DART AEROSPACE LTD		Work Order: 164557
Description: Crosstube High-High Fwd		Part Number: D205-596-105
Inspection Dwg: D205-596-105	Rev: B	Page 1 of 1

B	SUPPORT NOW MAGNOBONDED; REMOVE D2856-600-851 ABRASION STRIP; UPDATED NOTES; ADDED D3595-063-450 CUSHION; MS21920-25 WAS MS21920-24	MB	07.12.03
A	NEW ISSUE	DS	02.11.20
REV.	DESCRIPTION	BY	DATE
DESIGN	4	DART AEROSPACE LTD HAWKESBURY, ONTARIO, CANADA	
DRAWN	1	DRAWING NO. REV. B D205-596-105 SHEET 1 OF 2	
CHECKED	PH	TITLE SCALE CROSSTUBE ASSEMBLY, HI-HI FWD NTS	
MFG. APPR.	PH	COPYRIGHT © 2002 BY DART AEROSPACE LTD THIS DOCUMENT IS PRIVATE AND CONFIDENTIAL AND IS SUPPLIED ON THE EXPRESS CONDITION THAT IT IS NOT TO BE USED FOR ANY PURPOSE OR COPIED OR COMMUNICATED TO ANY OTHER PERSON WITHOUT WRITTEN PERMISSION FROM DART AEROSPACE LTD.	
APPROVED	PH		
DE APPR.	PH		
DATE	07.12.03

DRAWING NO. D205-596-105	TITLE CROSSTUBE ASS'Y, HI-HI FWD	REV. B	DART AEROSPACE LTD ENGINEERING ORDER		D.E.O. NO. D205-596-105-B-2	SHEET NO. SHEET 1 OF 1	SCALE NTS
DRAWN <i>q</i>	CHECKED <i>A.P.</i>	MFG. APPR. <i>A</i>	APPROVED <i>MP</i>		DE APPR. <i>H</i>		
DATE 13.11.11	DATE 13.11.19	DATE 13.11.19	DATE 13/11/21		DATE 13/11/21

DRAWING NO. D205-596-105	TITLE CR

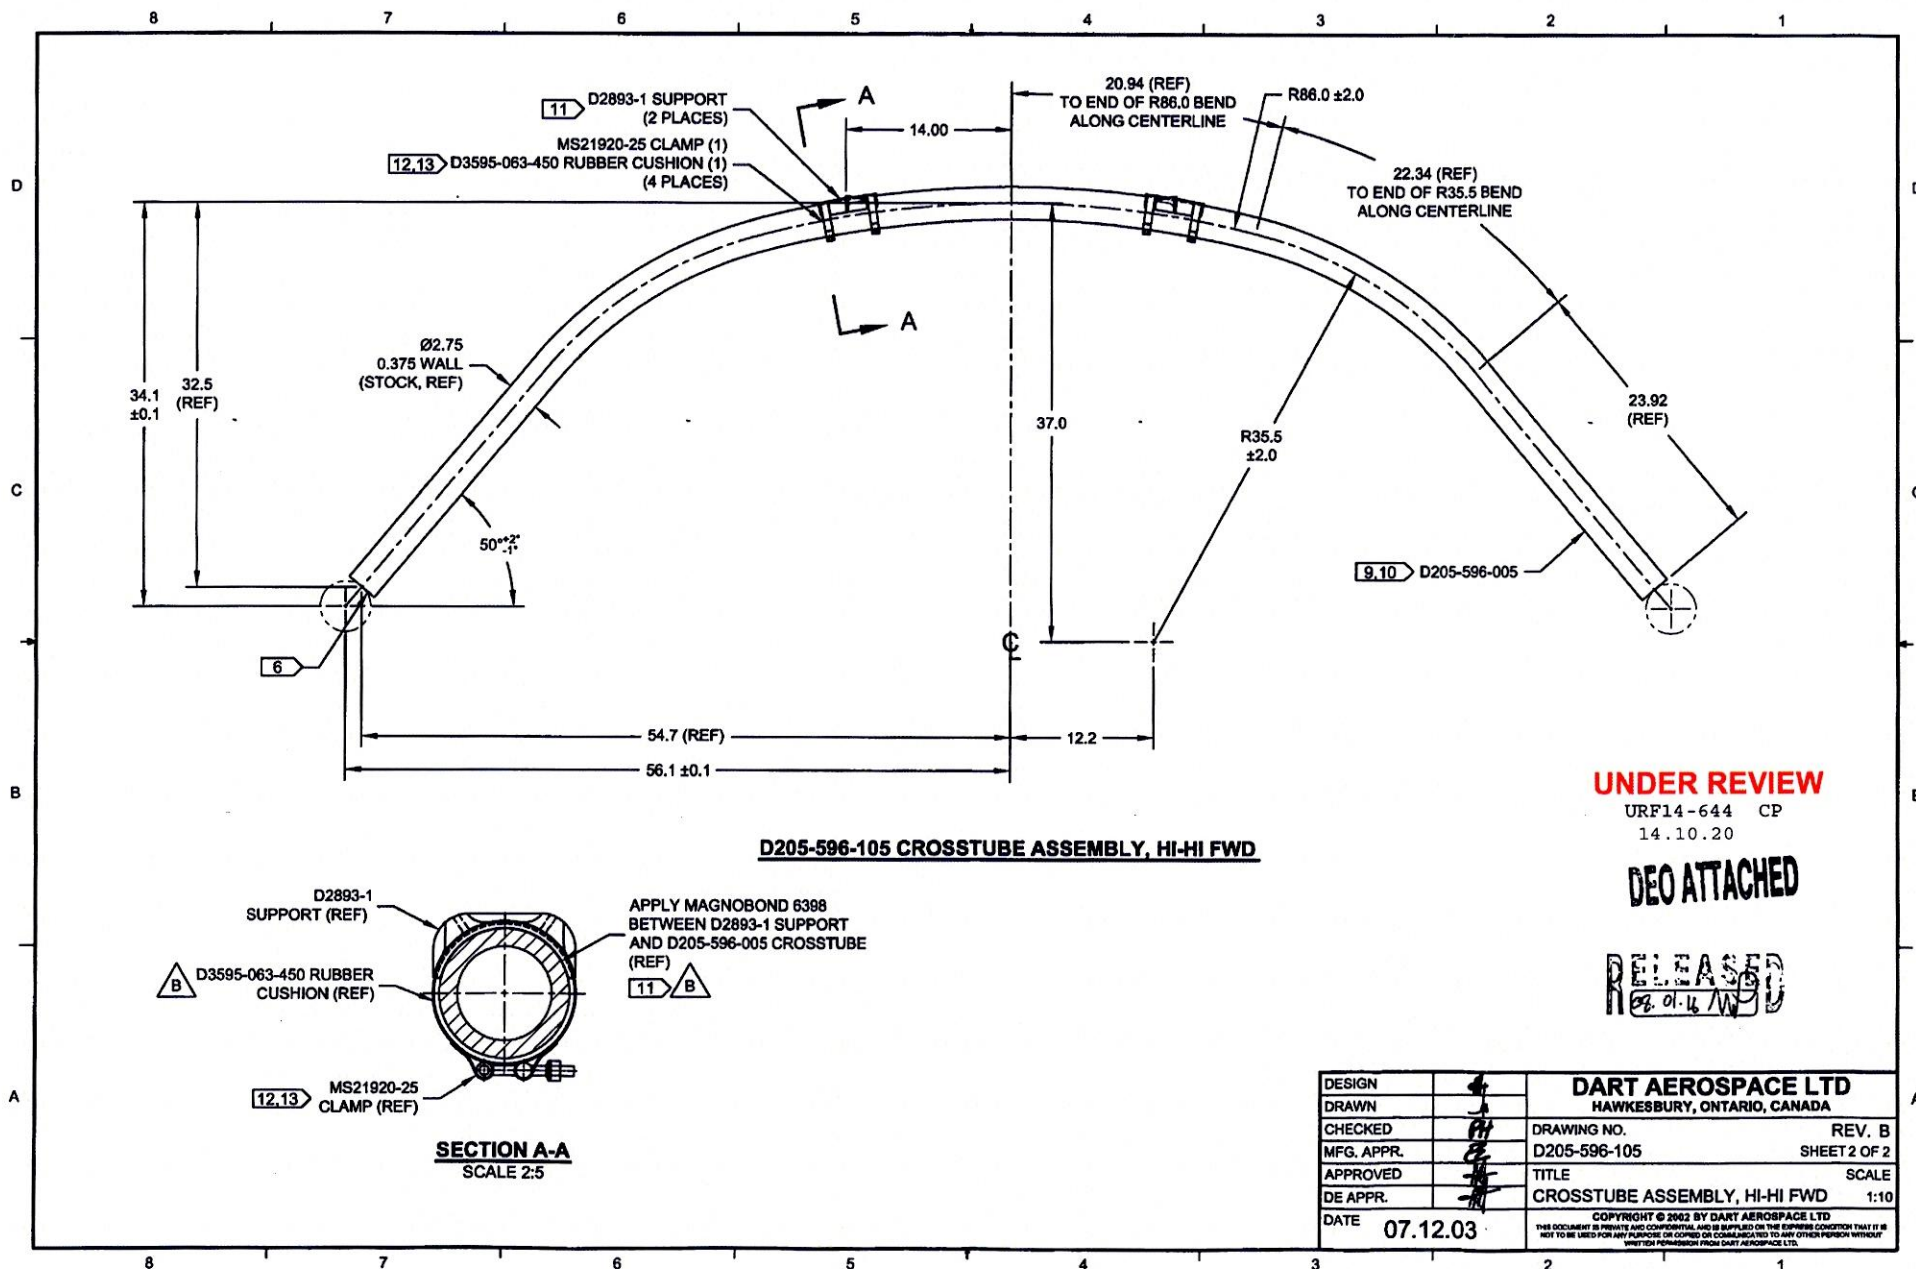
PURPOSE:

REPLACE MAGNOBOND WITH PROSEAL.

NOTE 11 & 13, SHEET 1 IS AMENDED AS FOLLOWS:

- 11) TO INSTALL D2893-1 SUPPORT: ABRASE MATING SURFACE OF SUPPORT AND CROSSTUBE WITH 180-GRIT SANDPAPER AND REMOVE RESIDUE WITH MEK (OR EQUIVALENT). APPLY A 0.04" TO 0.07" THICK LAYER OF PROSEAL 890 CLASS B-2 (OR AMS-S-8802 CLASS B-2) SEALANT TO MATING SURFACE OF SUPPORT.
- 13) TORQUE CLAMPS 80 TO 100 IN-LB. ENSURE AT LEAST 1.5 THREADS SHOWING IN SAFETY AND THAT NUT HAS NOT BOTTOMED-OUT AFTER TORQUING. PRIOR TO PACKAGING, RE-CHECK TORQUE ON CLAMPS AFTER PROSEAL 890 SEALANT HAS CURED FOR 72 HOURS.

FIGURE 1 - SUPPORT INSTALLATION

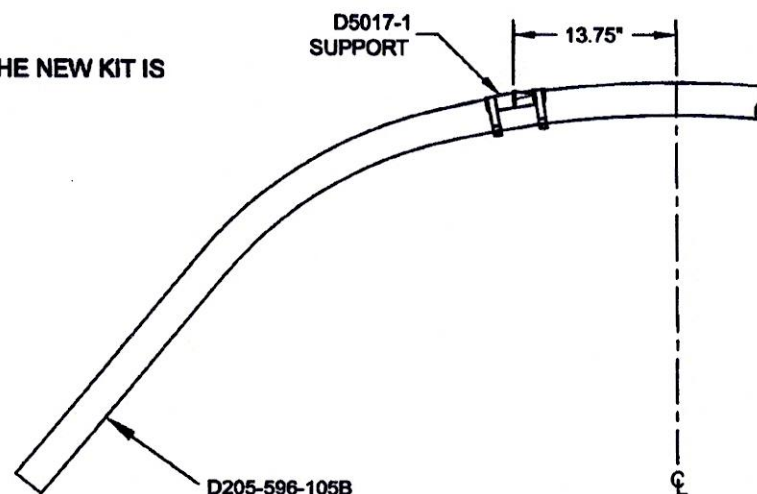
ADD THE FOLLOWING CROSSTUBE ASSEMBLY:

THE D205-596-105B CROSSTUBE HAS THE SAME PARTS LIST AS THE D205-596-105 CROSSTUBE EXCEPT AS FOLLOWS:

2	D5017-1	SUPPORT
---	---------	---------

INSTALL THE SUPPORTS AS SHOWN IN FIGURE 1 OF THIS ENGINEERING ORDER. THE NEW KIT IS OTHERWISE ASSEMBLED PER THE D205-596-105 CROSSTUBE.
